SLOUGH MULTIFUEL EXTENSION PROJECT

Planning Inspectorate Ref: EN010129

**Document Ref: 9.2 – Applicant’s Responses to the Examining
Authority’s First Written Questions (ExQ1)**

March 2023 – Deadline 2

Slough Multifuel Process Diagram

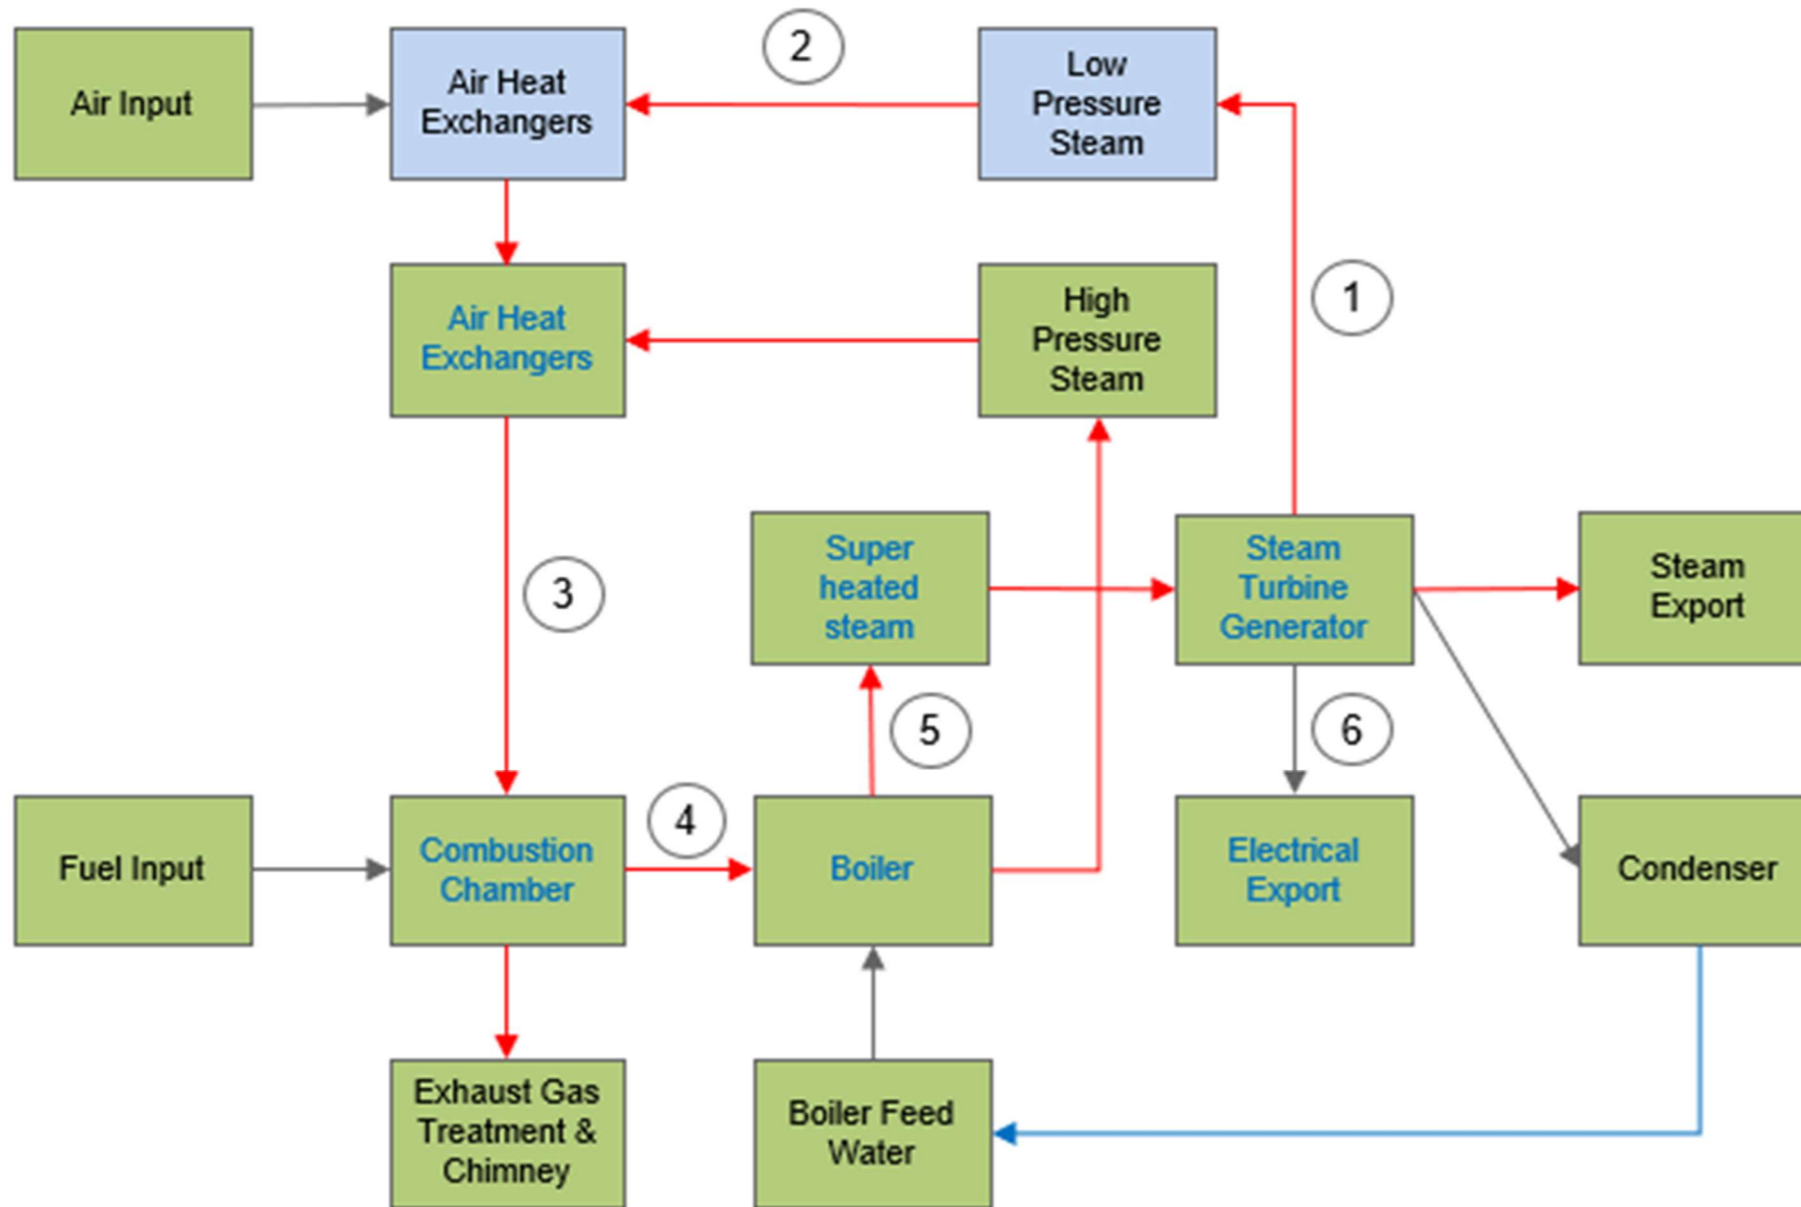
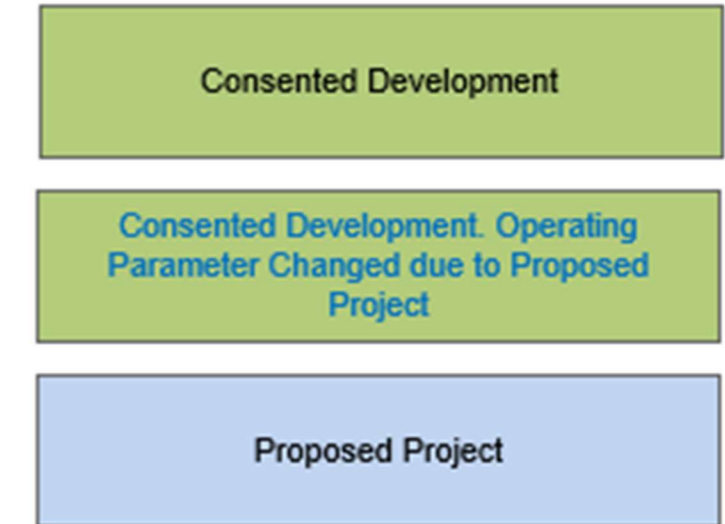
Air Quality and Emissions			
Q1.3.1	Applicant	Paragraphs 2.5.1 to 2.5.3 of ES Chapter 2: The Proposed Project [APP-027] and paragraph 8.1.5 of ES Chapter 8: Air Quality [APP-033], outline how the Proposed Development seeks to increase the generating capacity of the consented scheme. Please clarify the point at which (within the Energy from Waste process) the efficiencies and increased gross electricity generation capacity would be delivered by ‘interventions’ as part of the Proposed Development. For the ExA to better understand these points, the Applicant is requested to provide a process flow(s)/schematic block diagram(s) showing the Energy from Waste process which clearly identifies these interventions. In responding please have particular regard to the combustion element in demonstrating the assertions that “The Proposed Project does not introduce any new emissions nor change the exhaust gas parameters” (paragraph 8.8.16 of [APP-033]) and that the pre-heating of combustion air would be achieved without the use of additional fuel [APP-027, paragraph 2.5.1].	Further to the answer supplied in Q1.2.4 part b, the Consented Development includes 2 boilers with a total thermal capacity of 183MWt. The Proposed Project makes no changes to the boilers supplied for the consented development, their fuel consumption, or emissions. The intervention from the Proposed Project occurs where low pressure steam is extracted from the steam turbine and fed to air heat exchangers. The steam fed to the air heat exchangers increases the temperature of the combustion air being fed into the boilers which allows more steam to be produced for the same amount of fuel. The Proposed Project recovers energy which would otherwise have been wasted in the process. Please refer to the Slough Multifuel Process Diagram and Slough Multifuel Process Overview contained in Appendix 1 of this document.

- 1 Low pressure steam is extracted from the steam turbine
- 2 Low pressure steam is fed into new air heat exchangers increasing the combustion air temperature.
- 3 Combustion air is fed into the combustion chamber at increased temperature.
- 4 Increased energy recovery
- 5 Increased steam generation
- 6 Increased electrical output
